TO: Mercedes-Benz Dealer Principals, General Managers, Sales Managers, Service Managers, Parts Managers	FROM: Anthony Washington, Department Manager, Regulations and Certifications
Re: Launch Recall Campaign Notification Check Generator/Steering Harness Connections Model – Sprinter 907 Model Year - 2021 VS3LE54ELE	DATE: August, 2022

Campaign No. 2022080003, August, 2022

SUBJECT: **Model 907 Sprinter, Model Year 2021**
Check generator and steering wiring harness connections

D54.18-A048-79

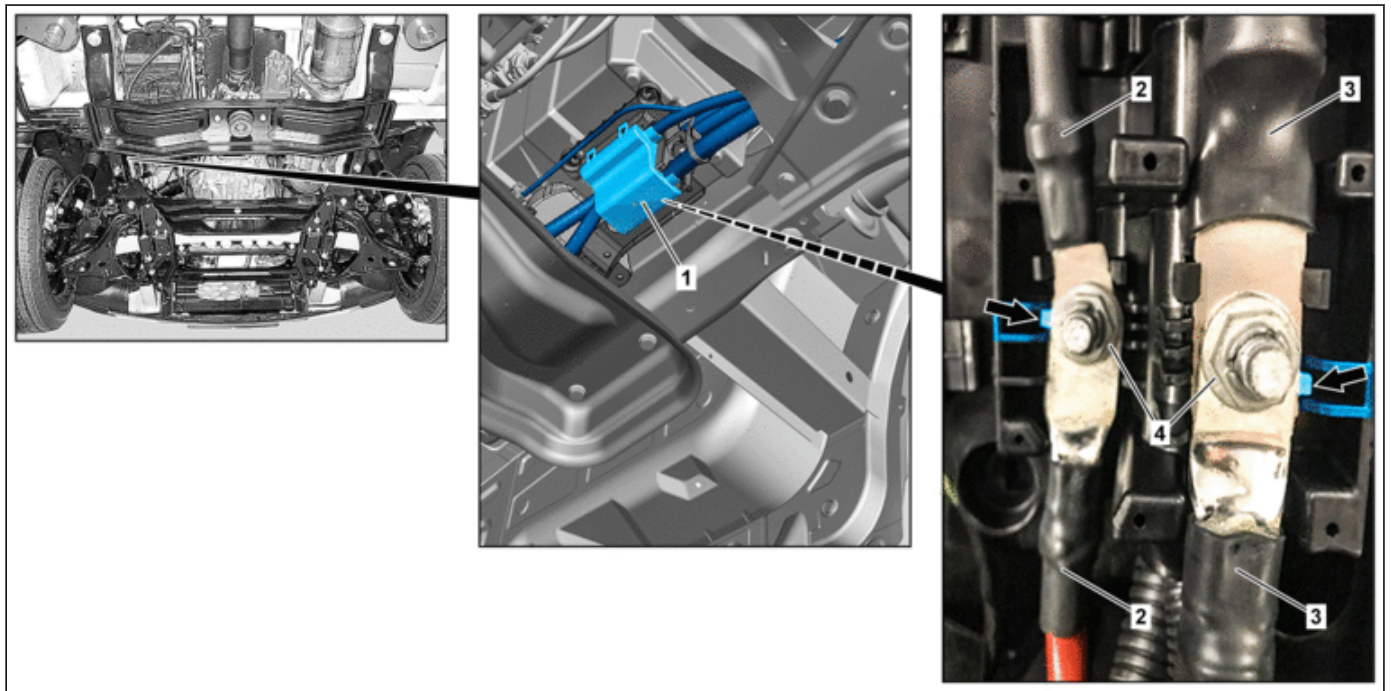
4	Remove cover (1).	 Clip remover	452 589 01 63 00
	Check		
5	Check screw connection of wiring harness for starter-alternator.	 To do so, check whether electric lines (2, 3) are installed as shown. The cross sections of the electric lines (2, 3) that are screwed to one other must be the same. Lugs (arrows) must line up with guides. If electric lines (2, 3) are correctly screwed to each other, ↓ continue with operation step 10 and finish measure. If electric lines (2, 3) are not correctly screwed to each other, ↓ continue with operation step 6.

Correct threaded connection		
6	Detach ground line of on-board electrical system battery.		AR54.10-D-0029TS
 AR			
7	Remove nuts(4).	 Nuts (4) can be reused.	
8	Position electric lines (2, 3) correctly.	 Observe the following: The cross sections of the electric lines (2, 3) that are screwed to one other must be the same. Lugs (arrows) must line up with guides.	
9	Attach nuts (4).	 Nm Nut, positive line to battery positive line connection on underbody	BA54.18-Z-1002-02KTS
	Install		
10	Install cover (1).		
11	Install underfloor paneling at left.	Model 907 with code XM1 (Noise abatement measures)	AR61.30-D-1001-02TS
 AR			
12	Lower vehicle.		
13	Connect ground line of on-board electrical system battery.	If screw connection for starter-alternator wiring harness was not correct.	AR54.10-D-0029TS
 AR
